MEMORANDUM

SUBJECT: Zoning Commission Case No. 14-01A–Final Report- **Modification**
Consolidated PUD, including a minor expansion of the PUD site area (1,785.7 square feet) and related Map Amendment from the C-M-3 to C-3-C zone district, at 1401-1535 New York Avenue, NE (Square 4037, Parts of Lots 0007 and 0804)

Proposed View from Okie Street (Plan - Pg. 10)

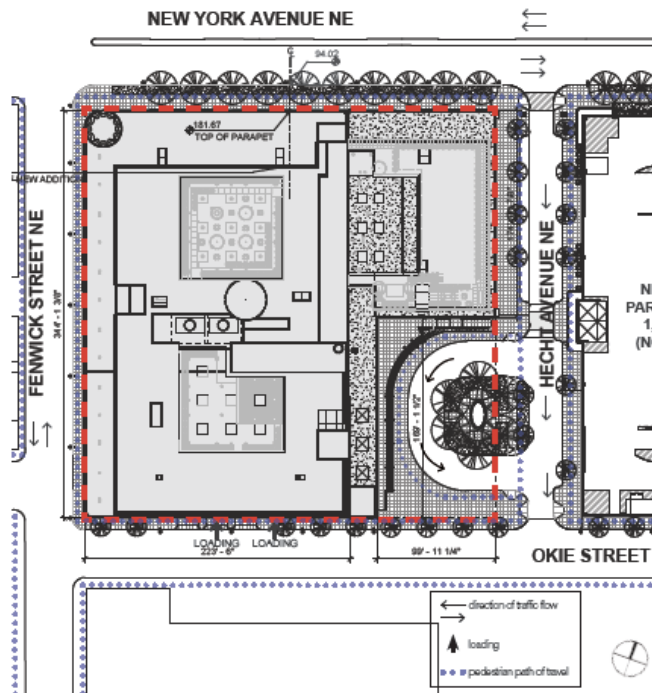
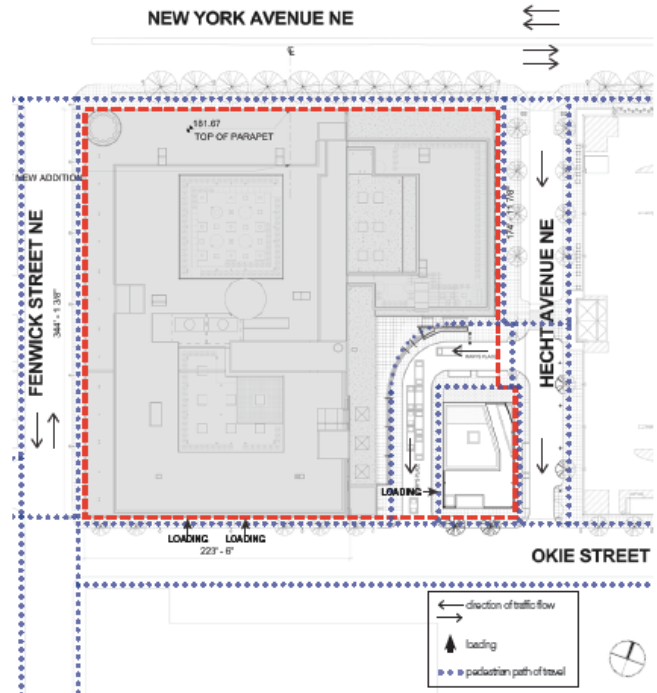
The Commission recommended some design changes to the large blank walls along the north, south and west facades of the proposed retail building, including a more festive appearance from all building sides. The applicant proposes to enhance these facades with glazed perforated metal panels, as shown in the plans. *A reflective surface would be placed behind the perforated panels to provide a “shimmering/glowing effect during the day.”* Bronze coated aluminum composite panels and portions clad in metal perforated panels would complete the building’s façade on both levels.

The drawings show the building set on a stone base, which would support glass panel storefronts along Hecht Avenue and Okie Street to enliven the street and provide visibility from within and outside of the building. The steel framed glass panel windows would allow for double glazing and operability, with the same profiles on both levels. On the ground level, the storefront may be opened up to sidewalk seating to animate the street. The applicant further explained that the use of cinder block at the building's base is an expression of the "industrial nature of the Hecht Warehouse district." (*Exhibit 23A– Building Elevations and Materials*, pgs. 16, 17, 19)
